Our Ref: 16241

**RE: CRESCENT PARKLANDS
RESPONSE TO SUBMISSIONS – ADDITIONAL INFORMATION**

As requested, please find herein The Transport Planning Partnership (TPPP)'s response to the agency advice provided on 1st December 2025. This letter provides additional information to address the issues raised.

Figure 1: Resulting Internal Road Route to Retail and Commercial

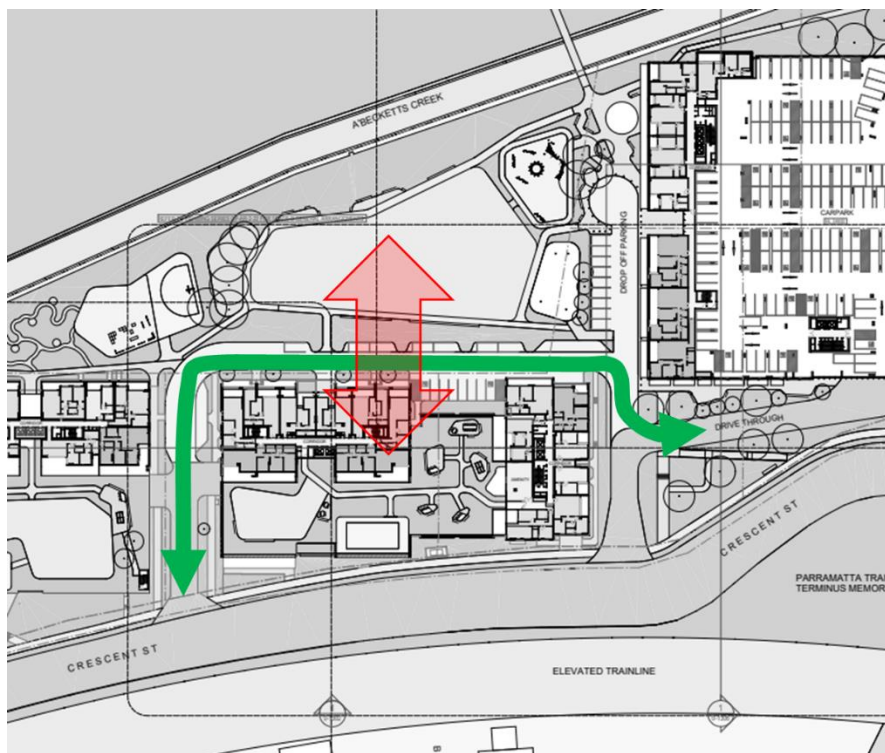
Accordingly, we maintain that no further works are required at this intersection as part of the SSDA.
Transport for NSW		
6	The other critical concern for TfNSW regarding the proposed development was the road safety impact of proposed eastern driveway in The Crescent. Whilst the RTS indicates that the impact of the right turning vehicles at the eastern driveway is unlikely to impact the existing traffic control signals (TCS) in terms of operational efficiency, TfNSW are of the view that the road safety issues have not adequately been addressed. In this regard, TfNSW reiterate our previous that eastern driveway should be restricted to left-in, left-out (LILO) movements only with right turn access being permitted from the western driveway only. To assist with the Applicant's staging concerns, TfNSW would be willing to accept an interim access arrangement condition that allows movements into and out of the site from the eastern driveway that would remain in place until the internal access road that links the eastern and western driveways is completed. Following the completion of the western driveway and internal access connection, the eastern driveway is to be restricted to LILO movements only.	TfNSW's comments regarding the road safety performance of right-turn movements at the eastern driveway are acknowledged. In response, the Applicant has undertaken a detailed reassessment of the auxiliary lane warrants and intersection geometry in accordance with <i>Austroads Guide to Road Design Part 4A</i>. This has resulted in a refinement to the Crescent Street design, with the right-turn bay extended to 52.5 metres (40 deceleration plus a 12.5 meters storage). The Crescent Street corridor provides sufficient width and longitudinal distance between the Woodville Road traffic control signals and the eastern driveway to accommodate the full-length auxiliary lane. This refinement significantly enhances deceleration, storage, and separation between through and turning vehicles, thereby resolving the road safety concern previously raised by TfNSW. With the updated design now: • providing a fully compliant Austroads auxiliary right-turn lane, • eliminating any risk of through-traffic conflict or queuing spillback, and • ensuring safe right-turn operation under both interim and ultimate traffic conditions, the Applicant's position is that permanent full-movements at the eastern driveway can be safely accommodated. We acknowledge TfNSW's preference for a LILO restriction in the long term; however, the updated analysis and geometric design demonstrate that the eastern driveway can continue to operate safely as a full-movement access point without adverse impact on the Woodville Road intersection or the broader network. (See additional information provided after this table)

Preventing the right turns at the eastern access would result in the need to make the internal road two-way and be wide enough to accommodate a truck and car to pass safely. The result would be a wide roadway through the development carrying more vehicles on what was intended to be shared zone (see Figure 1)

This would have an impact on the amenity of the residential stages B and C as well as the park and create more of a barrier between the residential buildings and the park lands. The current design allows for a quiet narrow one-way lane way that would support a share zone type environment.

The two-way internal road would also impact on the staging of the development should stage A be constructed first, then access would need to be maintained through the worksite to the west. This may create delays or congestion in accessing stage A during construction activities.

Figure 4: Extended Right Turn

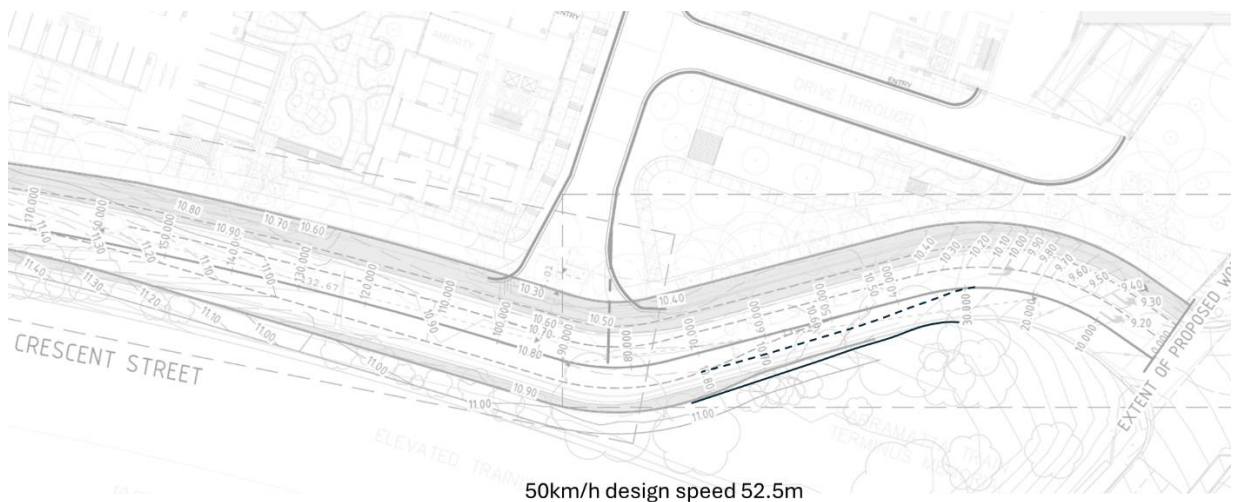
Site Access		
2	It is reiterated that the eastern driveway is located close to the signalised intersection at Woodville Road and that outstanding safety concerns require further consideration. While the applicant has undertaken modelling demonstrating that the eastern driveway will perform adequately, design deficiencies and influence of driver behaviour has not been given sufficient consideration. In this regard, it is noted that the proposed right turn bay in Crescent Avenue is only 25m as per the SIDRA layout. This appears to be non-compliant with section 5.2 of Austroads Guide to Road Design Part 4A (2023) as it would require vehicles to slow down within the through lane prior to entering the right turn bay. This would result in a rear end collision risk. The bay should be revised such that the total length allows for deceleration to the back of queue.	We do not consider that 100m to be 'close' to the intersection. The right turn length was conservatively modelled as 25m based on the effective storage lane length shown in the design. The design plans show the right turn bay starting at chainage 50 and ending 85 total of 35m. This is consistent with a CHR(s) design which does not require the distances in Austroads Guide to Road Design section 5.2. In response, the Applicant has undertaken a detailed review of the Austroads Guide to Road Design Part 4A (2023) right-turn lane warrants, including revised traffic flow inputs and storage requirements. This further assessment confirms that a full auxiliary right-turn lane is warranted at the eastern driveway. Accordingly, the Crescent Street design has been refined to increase the total right-turn bay length from 25 metres to 52.5 metres, comprising: • 12.5 metres of storage length, sufficient to accommodate the calculated back-of-queue under design peak traffic conditions, and • 40 metres of deceleration (including 15m taper), consistent with Austroads 4A guidance for a 50 km/h operating environment. The Crescent Street corridor provides adequate longitudinal distance between the Woodville Road traffic control signals and the eastern driveway to accommodate this full auxiliary lane within the proposed road reserve, without affecting pedestrian paths, landscape zones or adjoining interfaces. The updated design:

The right turn bay will be designed in accordance with the relevant Austroads guidelines. The 25m bay modelled in Sidra was for modelling purposes to account for the effective length of the bay. The original design was for a 35m as a CHR(s) in accordance with Austroads; however, a review of the warrants for turn treatments has identified that a full right turn CHR would be more appropriate at this location.

Therefore, the right turn bay is proposed to be lengthened. The length has been determined using Austroads Guidelines, specifically the Guide to Traffic Management Part 6 and the Guide to Road Design Part 4A. Through assessing the warrant and the dimensions of the bay.

The design speed for Crescent Street is based on the posted speed limit of 50km/h.

The deceleration length D is adopted from Austroads Guide Part 4A table 5.2 and for comfortable deceleration is a distance of 40m.

The storage S is based on the traffic modelling and would require storage for at least one vehicle. In this case, it would be equal to the design vehicle, a 12.5m heavy rigid truck.

The resulting turn bay would be 52.5m long. The length of the taper adopted is 15m taken from Table 5.1 of Austroads Guide to Road Design, Part 4A.

The resulting extended right turn bay is shown in Figure 4.

Figure 5: Sight distance Splays

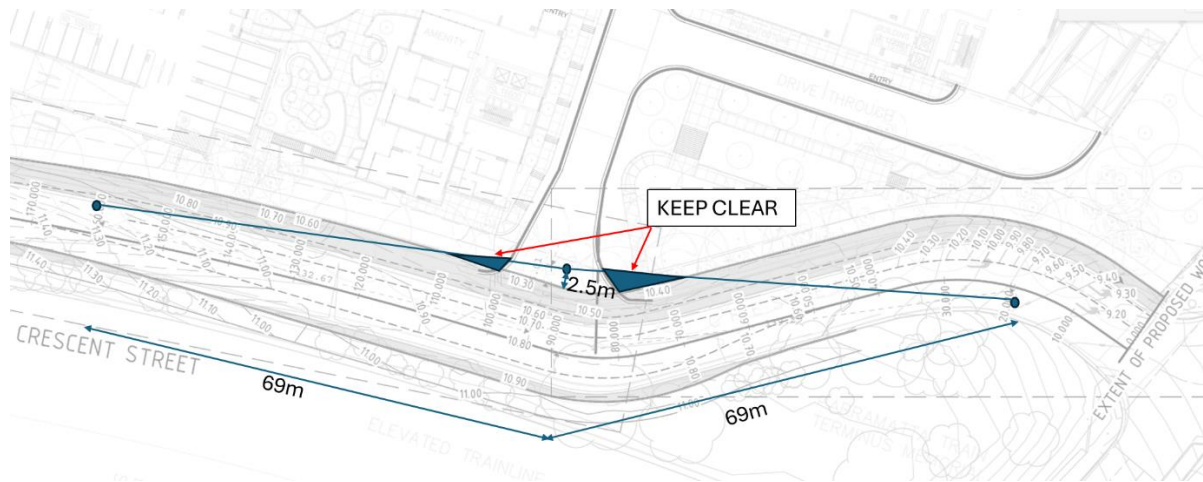
- meets or exceeds Section 5.2 of Austroads Guide to Road Design Part 4A (2023), - provides a compliant deceleration path ensuring that vehicles are removed from the through lane prior to slowing, - eliminates the rear-end collision risk referenced in the TfNSW comment, - provides sufficient queue storage to avoid spillback toward the Woodville Road intersection, and - materially improves the overall road safety performance of the eastern driveway. With this refinement, the design deficiency identified by TfNSW is now fully addressed, and the right-turn movement can be safely accommodated in accordance with Austroads criteria. (See additional information provided after this table)
3	With the sight line assessments provided in the updated TIA, it is unclear if this considered the proposed landscaping along the nature strip as indicated in the landscaping plans. Accordingly, the assessment should be updated to ensure that no vegetation is planted that may compromise driver sight lines.	A condition is proposed to ensure there is no potential impacts from vegetation that would compromise driver sightlines. Proposed Condition Sight lines from the driveway to Crescent Street must be maintained in accordance with the sight distance requirements shown on the Figure 5 prepared by TPP. No vegetation, including trees, shrubs or other landscaping elements, is to be planted or retained within the identified sight line areas that would compromise driver visibility. Should existing vegetation within these areas be retained, it must be pruned or managed to ensure compliance with the sight distance requirements.

It is agreed that sight distance will be maintained in the locations identified in Figure 5, and these areas will be kept clear of any vegetation or built elements that could obstruct driver visibility. A condition is proposed to ensure ongoing protection of the required sight lines.

Sight lines from the driveway to Crescent Street must be maintained in accordance with the sight distance requirements shown on Figure 5 prepared by TPP, dated 12 December 2025.

No vegetation, including trees, shrubs or other landscaping elements, is to be planted or retained within the identified sight line areas if it would compromise driver visibility.
